UNITED STATES
NUCLEAR REGULATORY COMMISSION
WASHINGTON, D.C. 20555-0001

SAFETY EVALUATION BY THE
OFFICE OF NUCLEAR MATERIAL SAFETY AND SAFEGUARDS
CATAWBA STANDBY NUCLEAR SERVICE WATER POND
DOCKET NOS. 50-413 AND 50-414

Figure 1 - Catawba Nuclear Service Water Pond

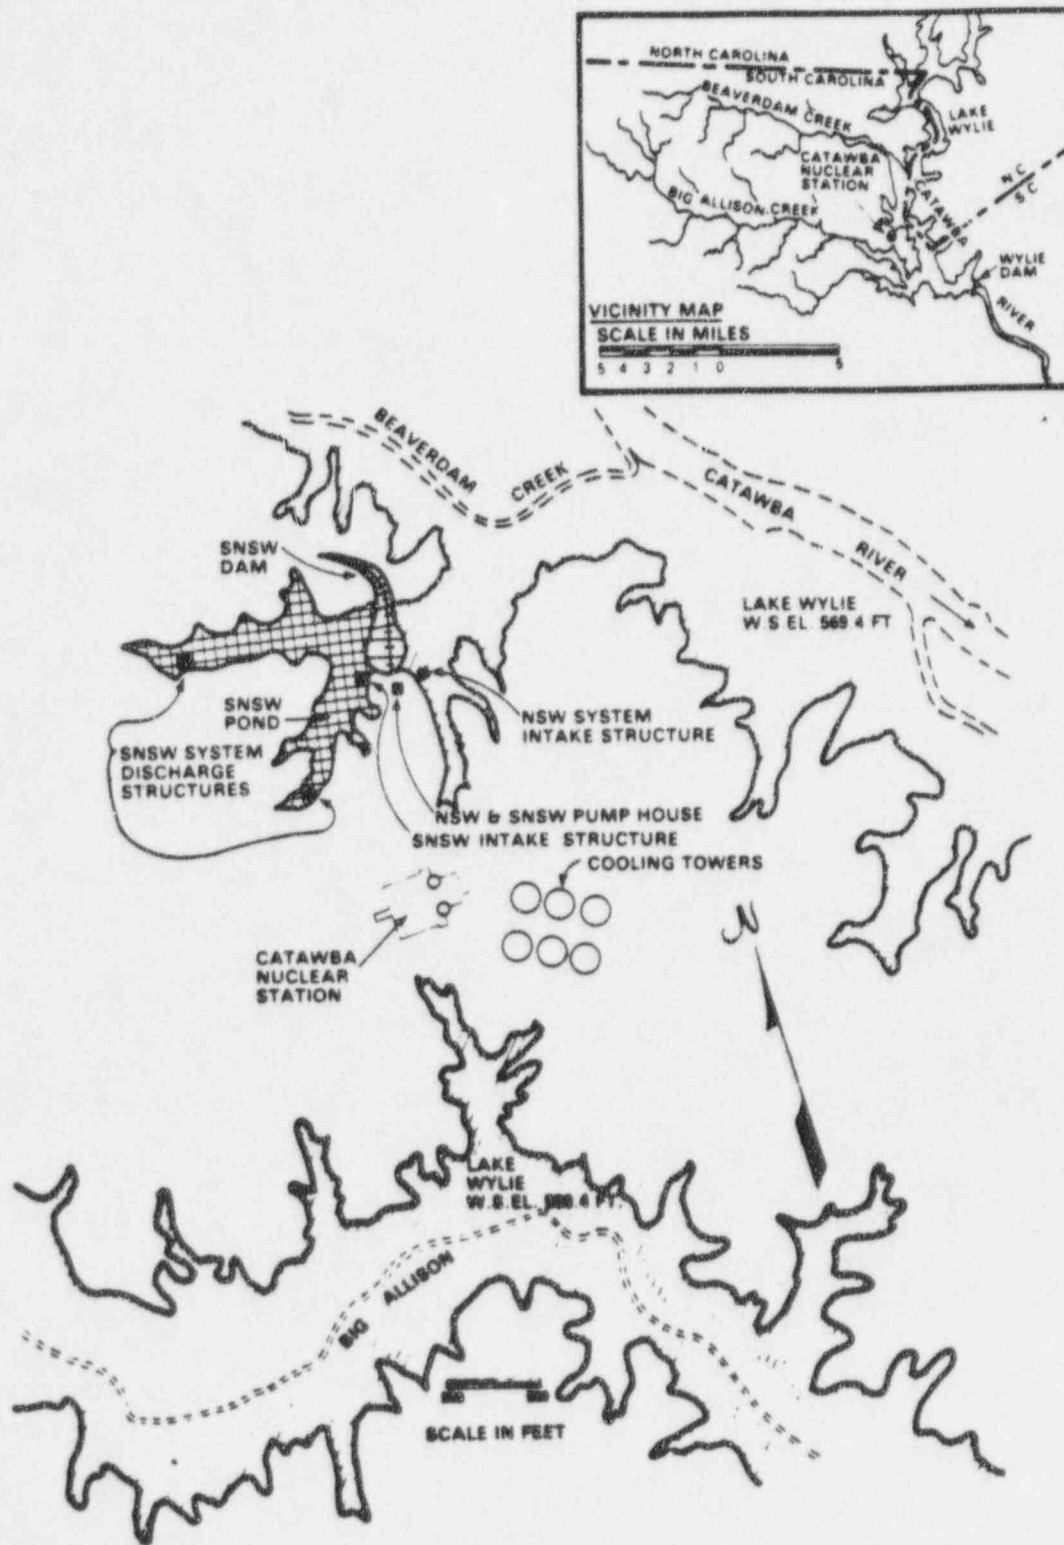
The Catawba Standby Nuclear Service Water Pond (SNSWP), shown in Figure 1, is an essential part of the ultimate heat sink (UHS) for the Catawba Nuclear Station, providing a back-up water supply in the event of a failure of the supply from Lake Wylie. The pond consists of a small impoundment of Lake Wylie, with two surface thermal outfalls and a single submerged intake. The pond must be capable of supplying cooling water below 92°F for up to 12.5 hours, and below 100°F for 30 days.

Figure 5 - Measured Pond Temperature

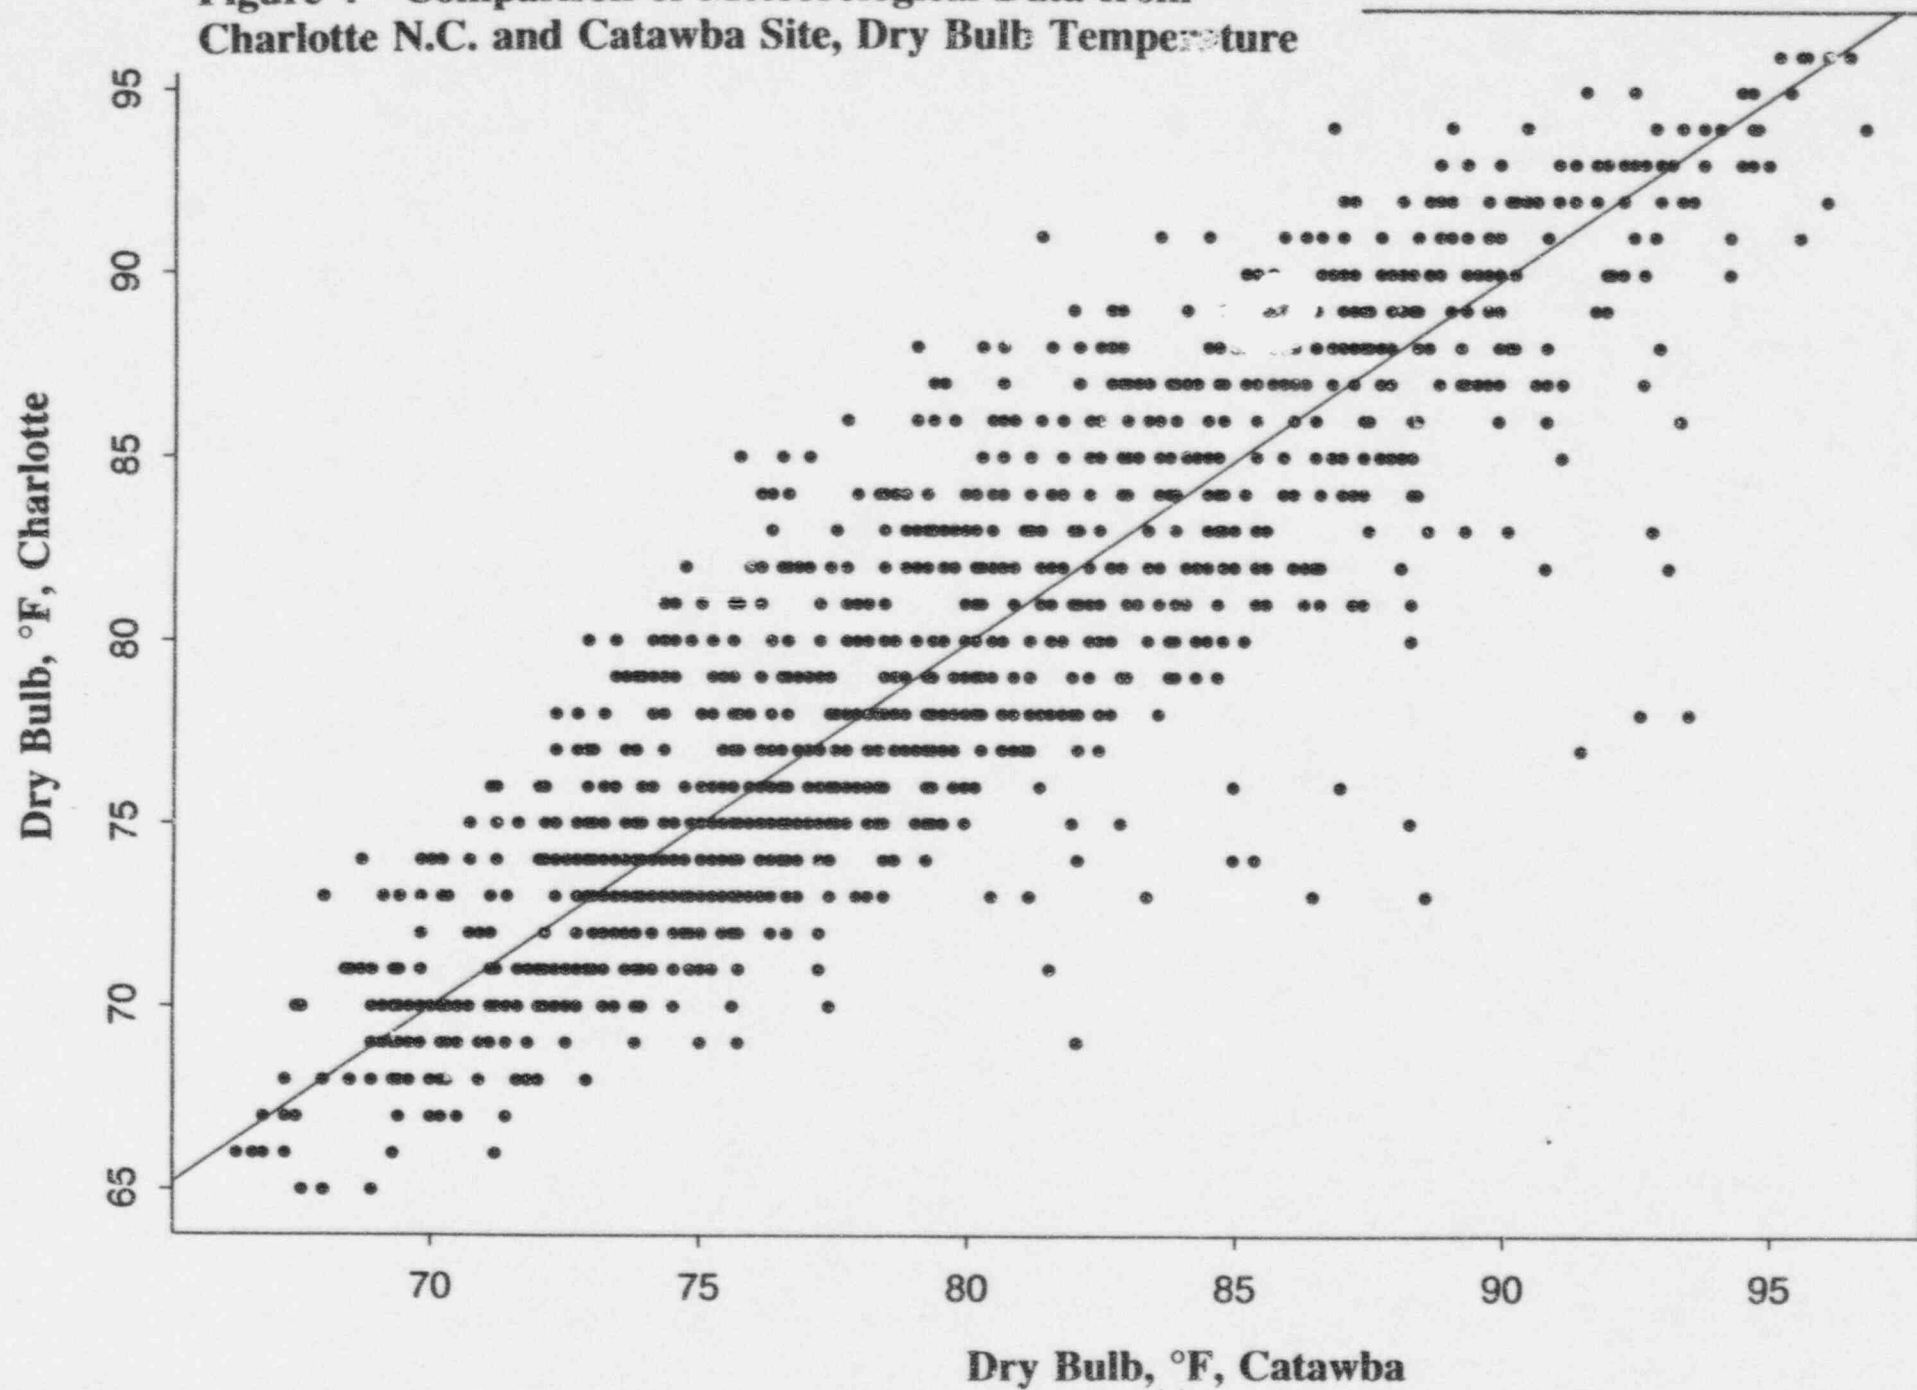
It is interesting to note that the peak unloaded temperatures for a totally mixed pond calculated with the CATU2 model was about 89.6°F. Figure 5 shows measured pond temperatures for the pond in July 1995. The measurement station was not indicated in the figure, but is probably a near-surface location based on the obvious diurnal variations. Figure 2 shows the strong pond stratification for summer months, indicating that there would be high stability and little vertical mixing during this period in the absence of flow. Running the model with the same meteorological data for a shallower

pond to simulate a stratified surface layer showed, as expected, a greater peak temperature; i.e., 89.6°F for a 10 foot thickness, 92.8°F for a 4 foot thickness and 95.5°F for a 2 foot thickness. The model results are qualitatively similar to temperatures observed in the field.

Figure 6 - Heat Load for Catawba UHS Analysis

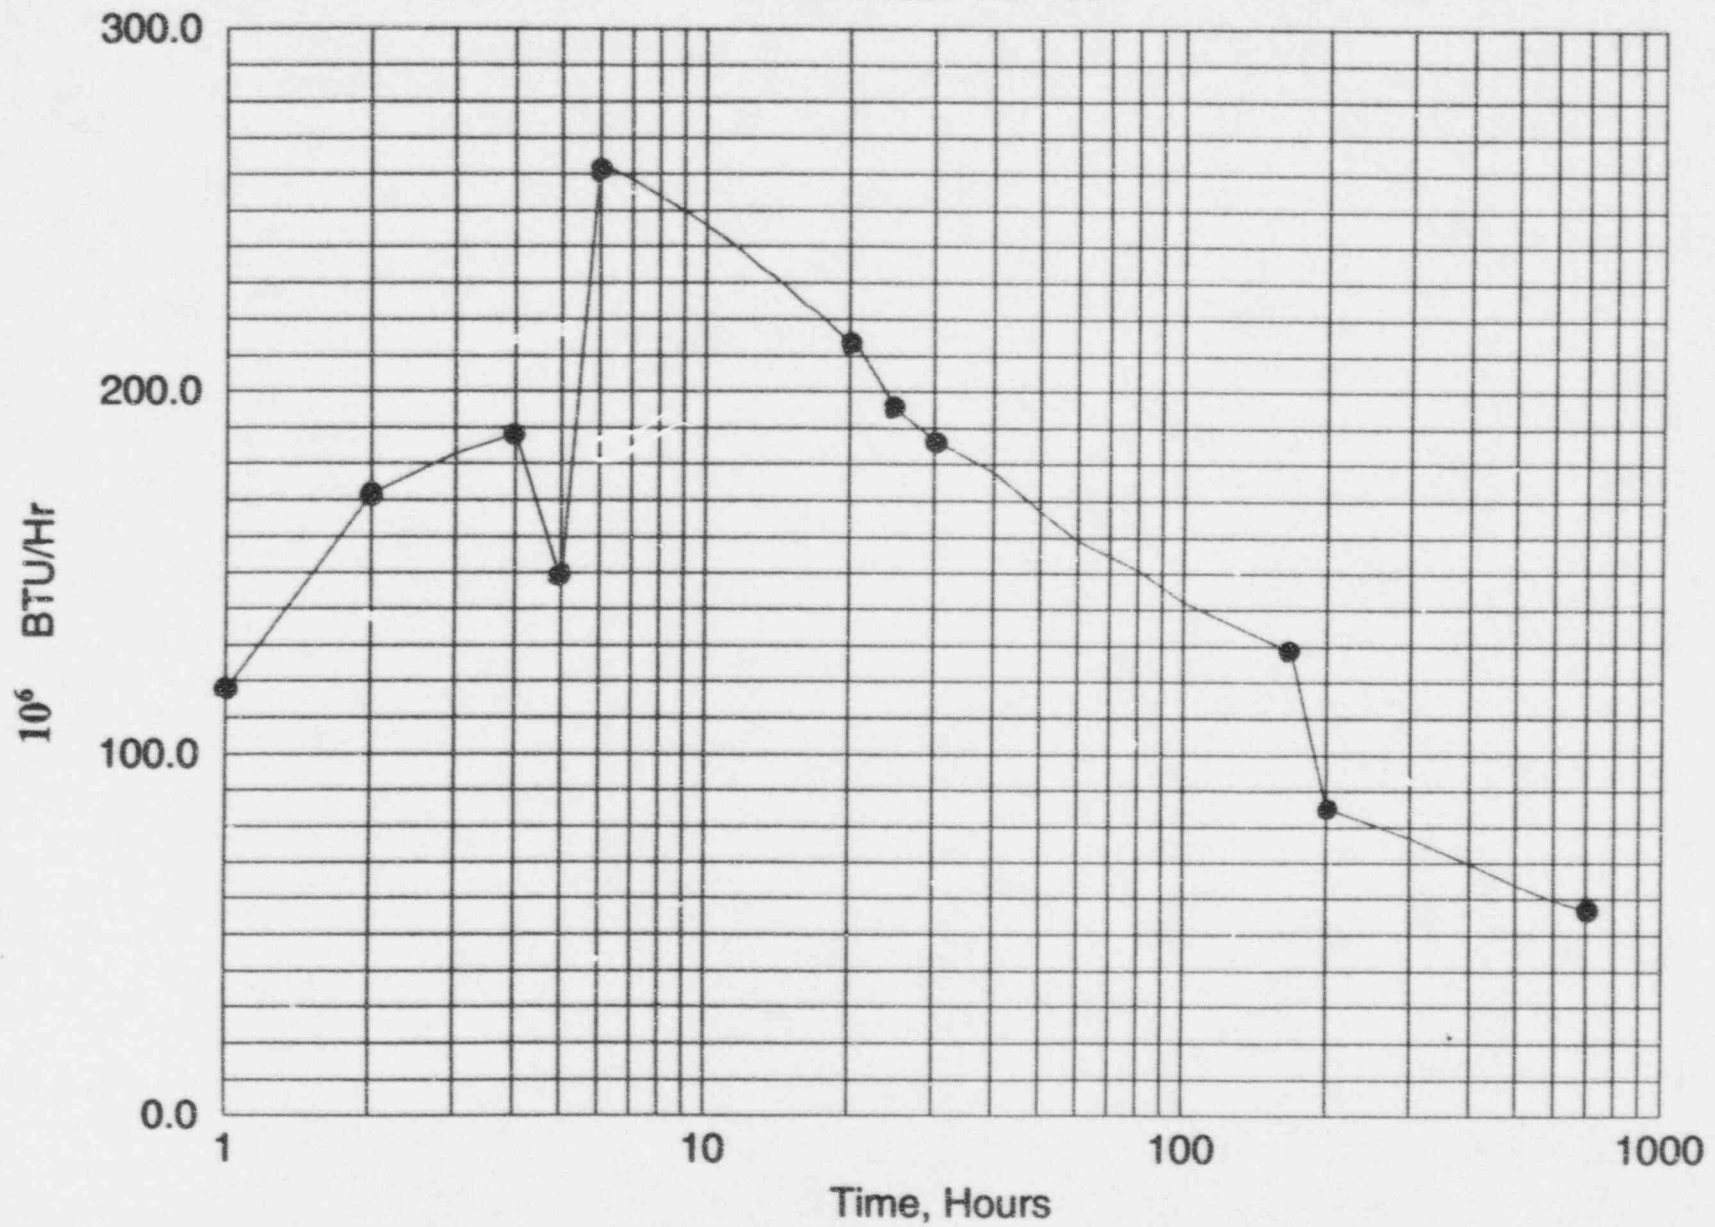
The pond models were run with 100 percent of the heat load and flow rate, for the 60-day period centered on 12:00 P.M., July 28, 1977, determined from the initial screening of the meteorological data. The 100-percent heat load curve is shown in Figure 6. Initial pond volume was 1.89×10^7 ft³, with constant pond surface area 1.65×10^6 ft². The model was run numerous times, with the starting time changed in 4-hour increments in order to align the peak meteorology and heat load timing, and the highest temperature for each of the three models (mixed, stratified or plug flow) was chosen from all runs.
